STATE OF UTAH DEPARTMENT OF NATURAL RESOURCES DIVISION OF OIL, GAS AND MINING						FORM 3 AMENDED REPORT <input checked="" type="checkbox"/>					
APPLICATION FOR PERMIT TO DRILL						1. WELL NAME and NUMBER Appaloosa 9-12D-5-5

Appaloosa 9-12D-5-5

BOPE REVIEW

APPALOOSA OPERATING COMPANY LLC Appaloosa 9-12D-5-5 43013515960000

Casing Schematic

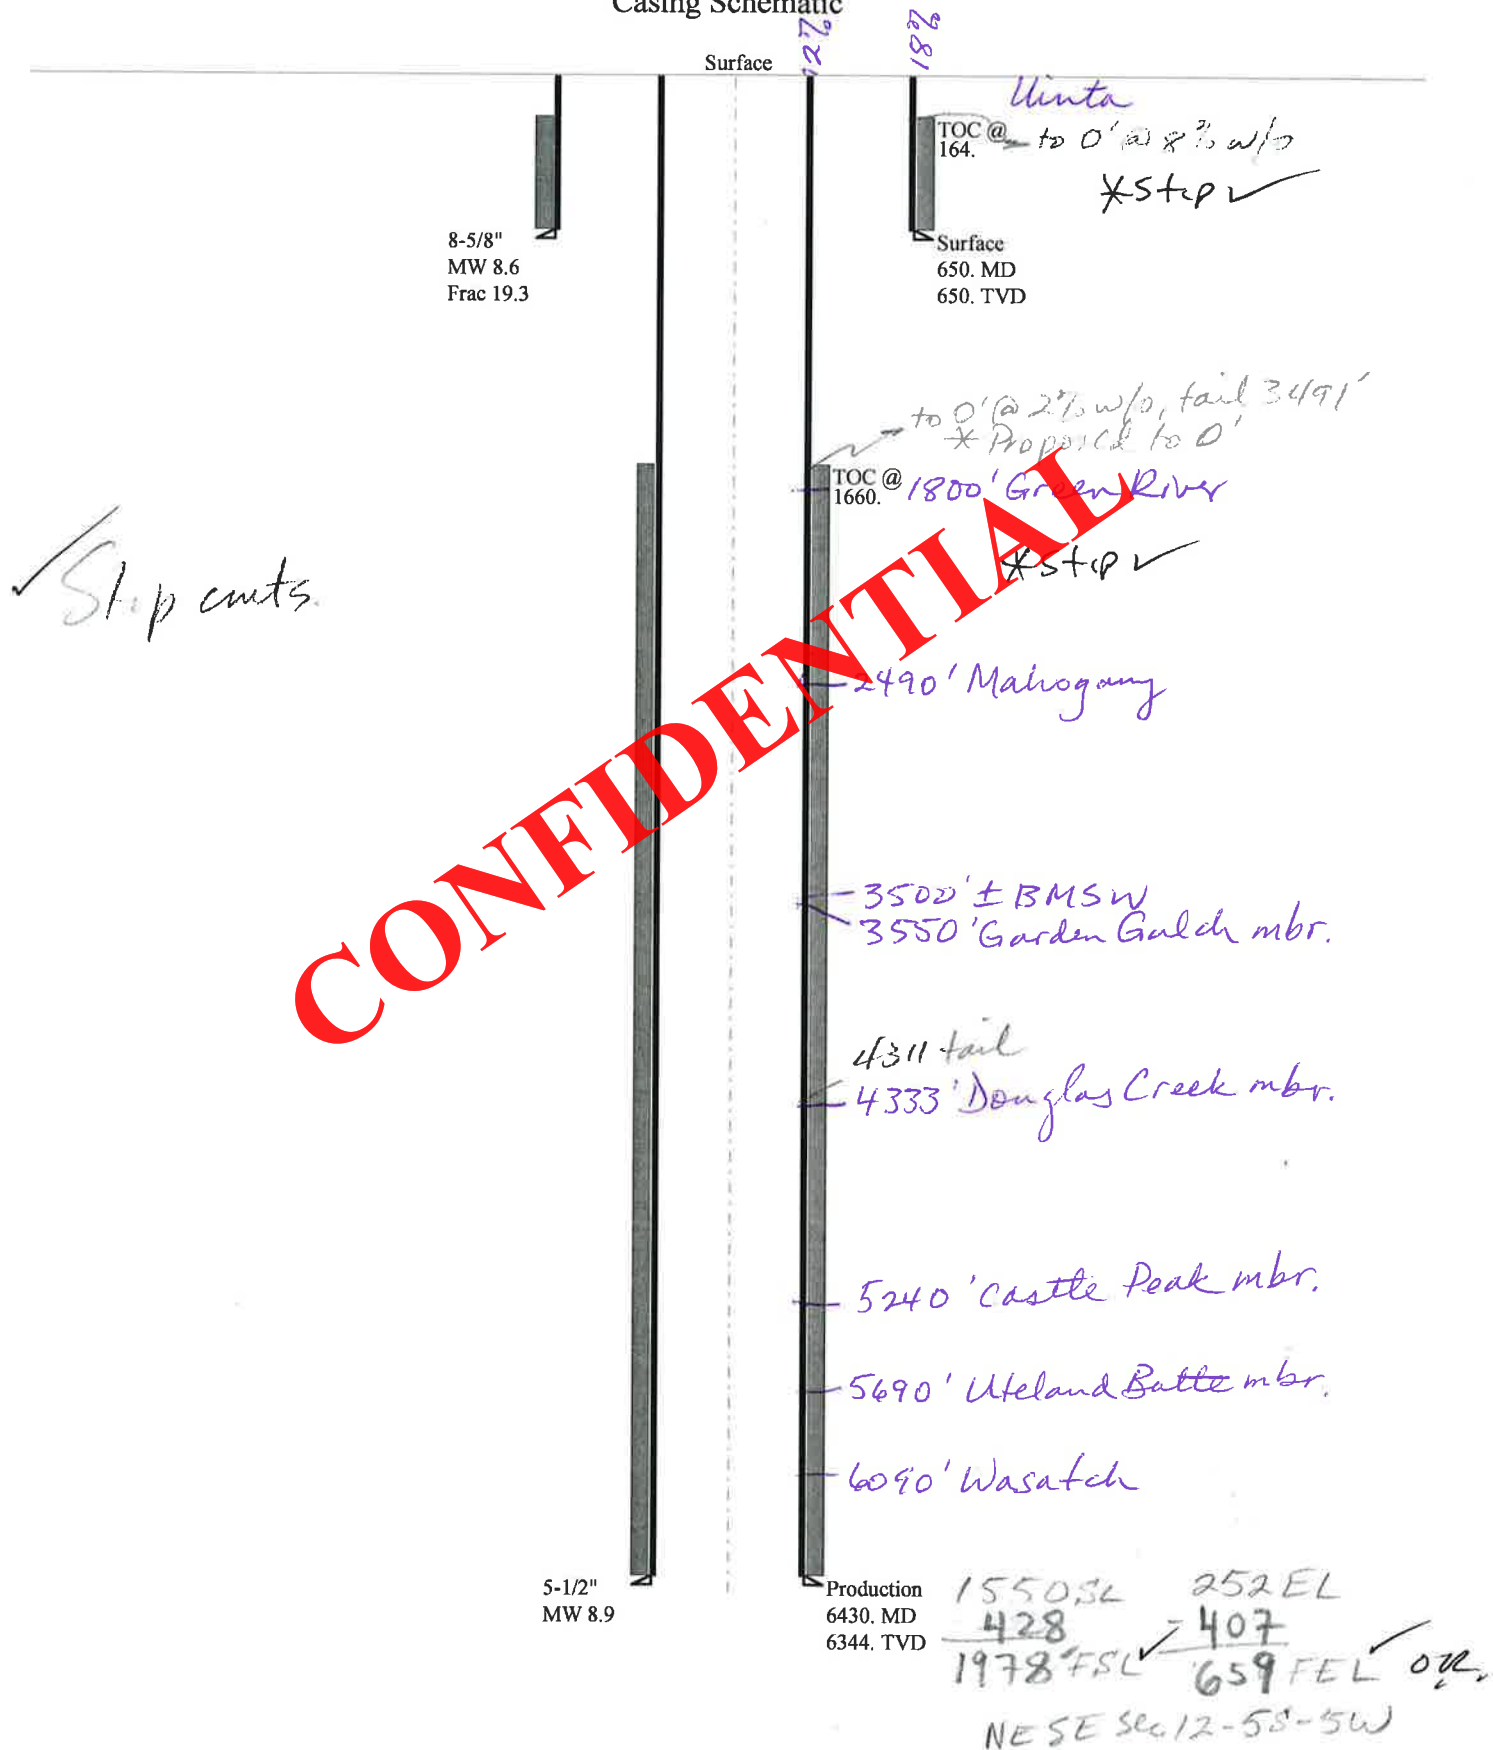
Calculations	SURF String	8.625	"
Max BHP (psi)	.052*Setting Depth*MW=	291	
			BOPE Adequate For Drilling And Setting Casing at Depth?
MASP (Gas) (psi)	Max BHP-(0.12*Setting Depth)=	213	NO <input type="text" value="FW spud mud"/>
MASP (Gas/Mud) (psi)	Max BHP-(0.22*Setting Depth)=	148	NO <input type="text" value="OK"/>
			*Can Full Expected Pressure Be Held At Previous Shoe?
Pressure At Previous Shoe	Max BHP-.22*(Setting Depth - Previous Shoe Depth)=	148	NO <input type="text" value=""/>
Required Casing/BOPE Test Pressure=		650	psi
*Max Pressure Allowed @ Previous Casing Shoe=		0	psi *Assumes 1psi/ft frac gradient

Calculations	PROD String	5.500	"
Max BHP (psi)	.052*Setting Depth*MW=	2936	
			BOPE Adequate For Drilling And Setting Casing at Depth?
MASP (Gas) (psi)	Max BHP-(0.12*Setting Depth)=	2175	NO <input type="text" value=""/>
MASP (Gas/Mud) (psi)	Max BHP-(0.22*Setting Depth)=	1540	YES <input type="text" value="OK"/>
			*Can Full Expected Pressure Be Held At Previous Shoe?
Pressure At Previous Shoe	Max BHP-.22*(Setting Depth - Previous Shoe Depth)=	1683	NO <input type="text" value="Reasonable"/>
Required Casing/BOPE Test Pressure=		2000	psi
*Max Pressure Allowed @ Previous Casing Shoe=		650	psi *Assumes 1psi/ft frac gradient
